**STAFF REVIEW FOR PLANNING BOARD APPROVAL  
TRENNEY LEA MAJOR SUBDIVISION PRELIMINARY PLAT REVIEW**

**Trenney Lea Subdivision, Preliminary Plat Review – Kenny Eason**, applicant, on behalf of Legend Builders, Inc., owner, is requesting approval of a preliminary plat for Trenney Lea Subdivision. Trenney Lea Subdivision consists of 10 lots on 76.72 acres. The property is zoned R-20, Residential and is located off Hoover Road, just north of Renee Road, in Hampstead, NC.

**TRENNY LEA SUBDIVISION**  
Proposed Subdivision Preliminary Plat  
Township Pender County North Carolina

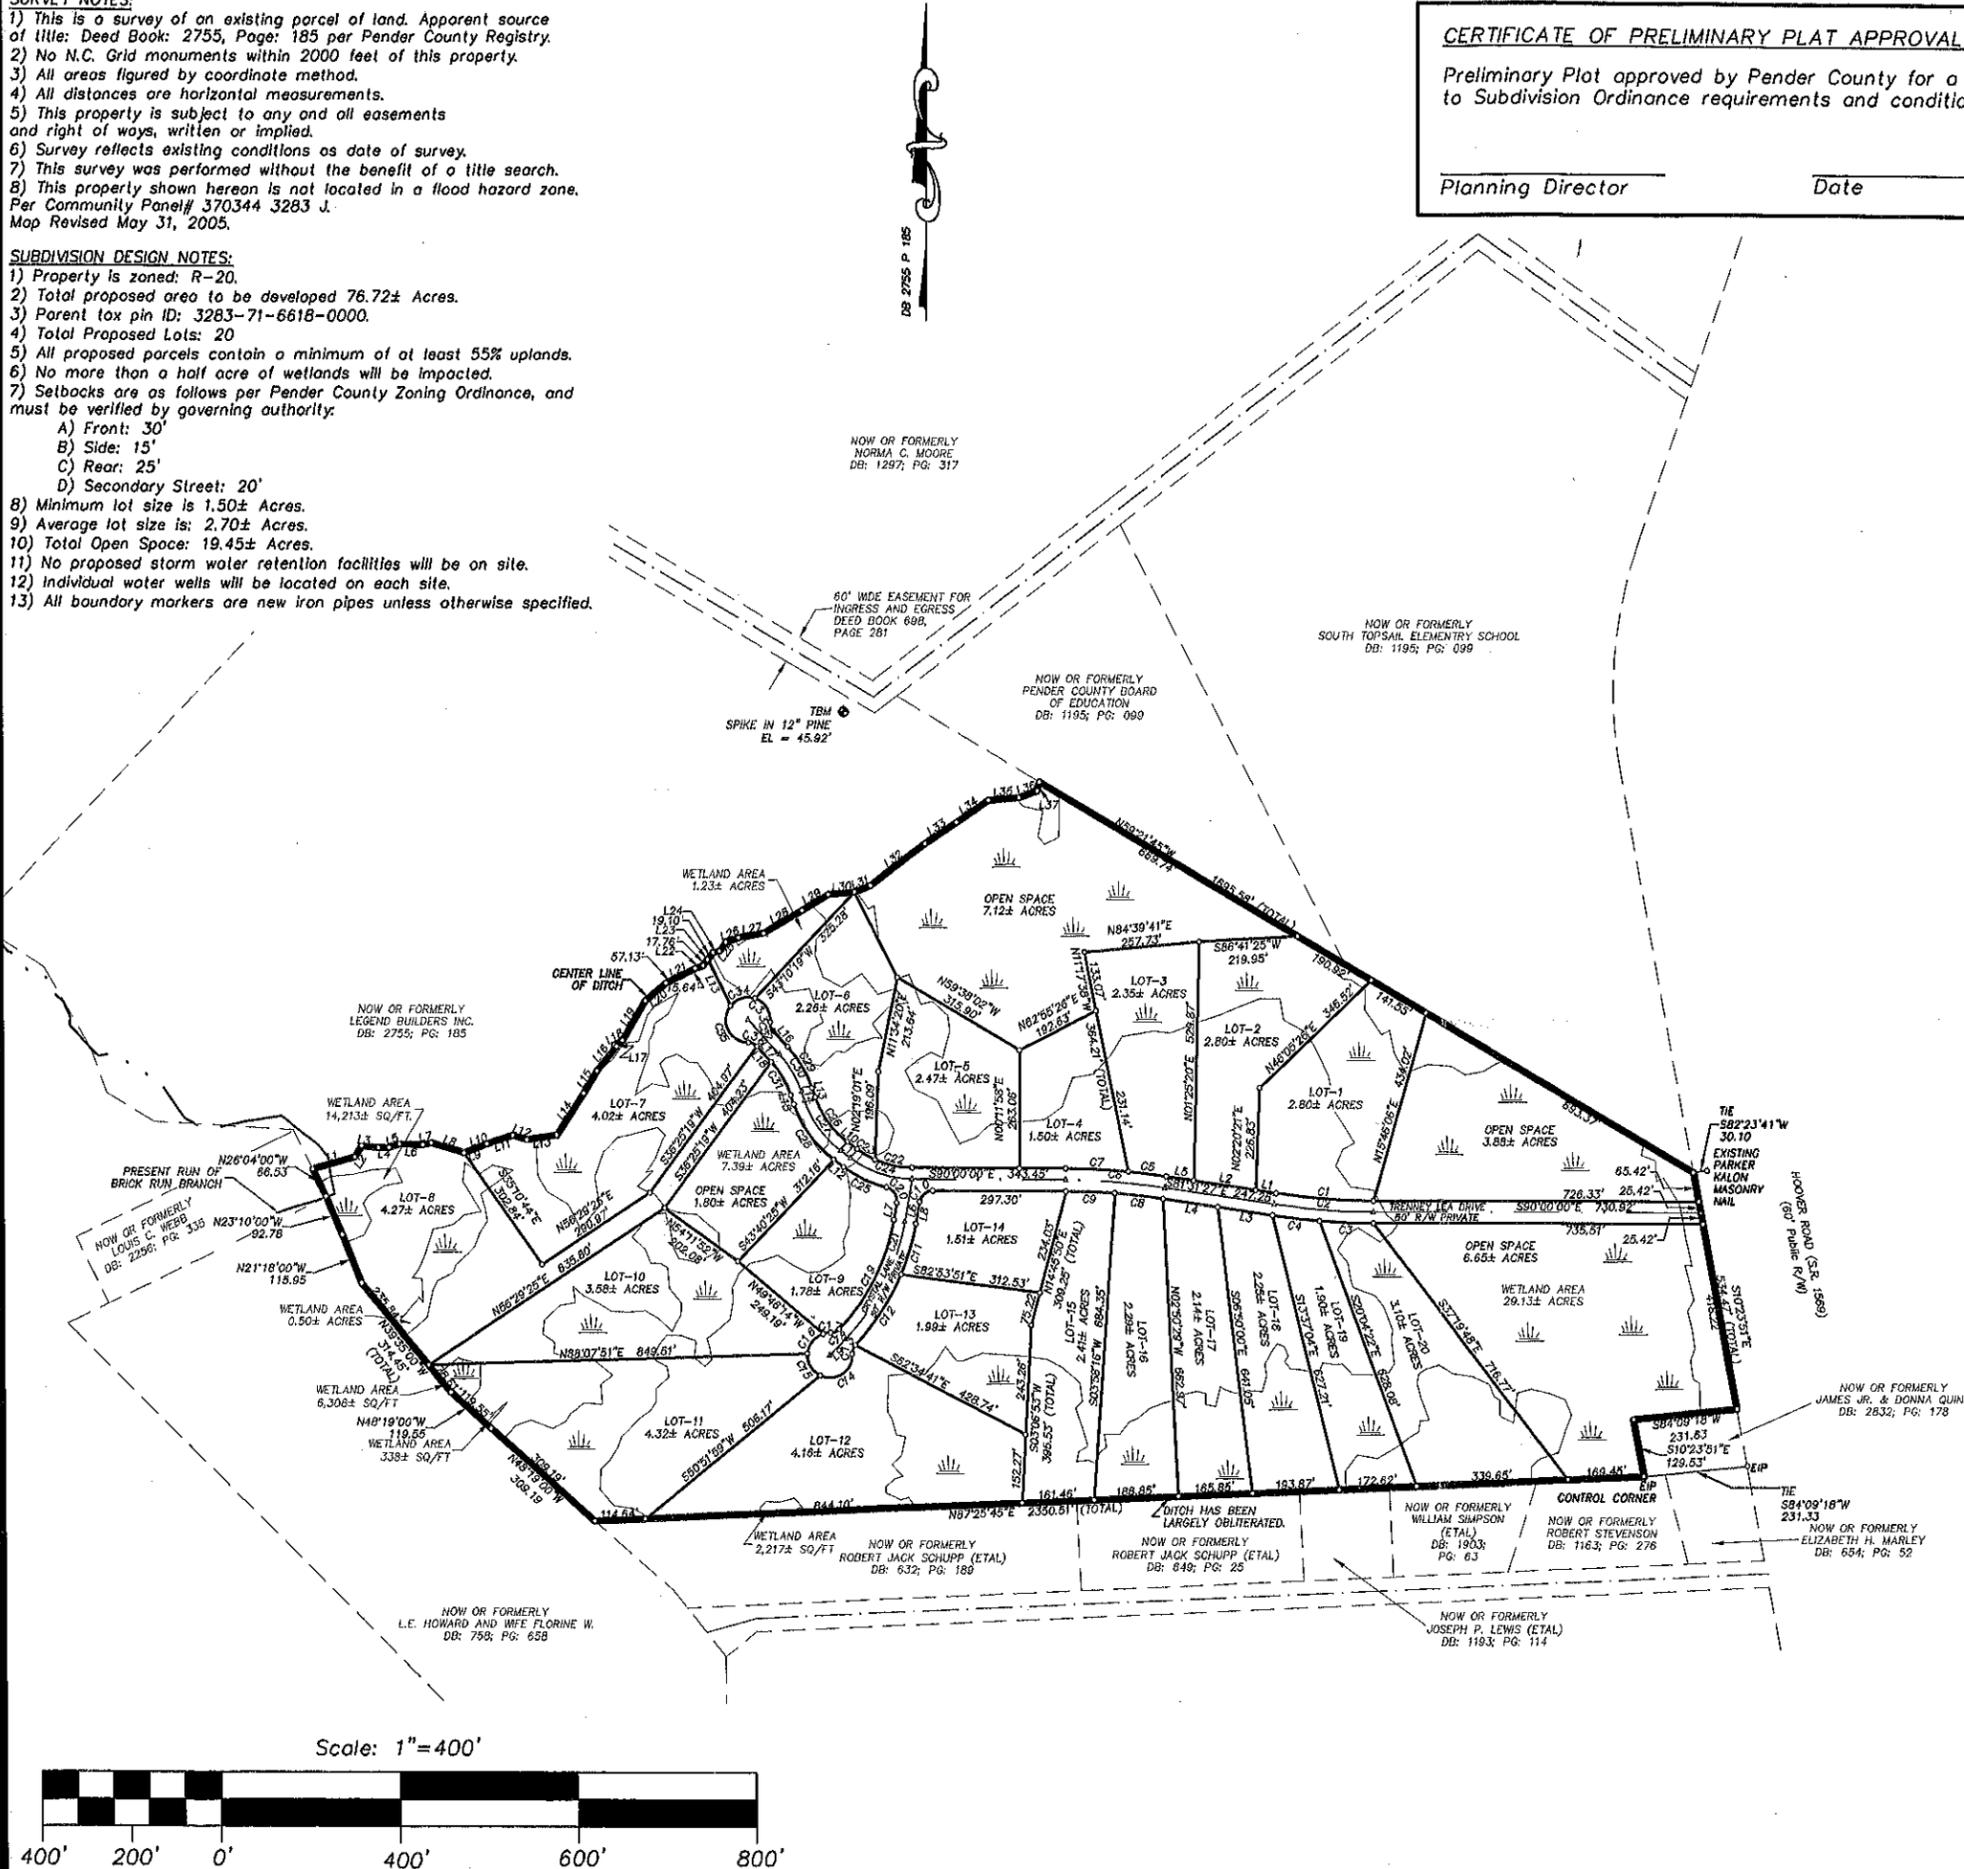
Additional comments from the MPO were read into the record concerning the Hoover Road and Hwy 210 connection.

Ken Eason, owner of the property stated that he was trying to minimize the impact instead of increase. He doesn't understand MPO's suggestion of putting a road through the middle of the proposed subdivision.

Rick Garrett stated that he thinks the intent is to allow for interconnectivity to be able to tie into the property. He suggested that Renee Drive is a better choice than what MPO chose.

Vice-Chairman stated that there needed to be a 10' access easement to the open space at the back of the lot.

Rick Garrett motioned that the request be approved as proposed with the items provided by staff and with the condition that open space on the western portion of the property either be connected to one of the other lots or access of a footpath be provided to the homeowner. Karen Gonzales seconded, the vote was unanimous.
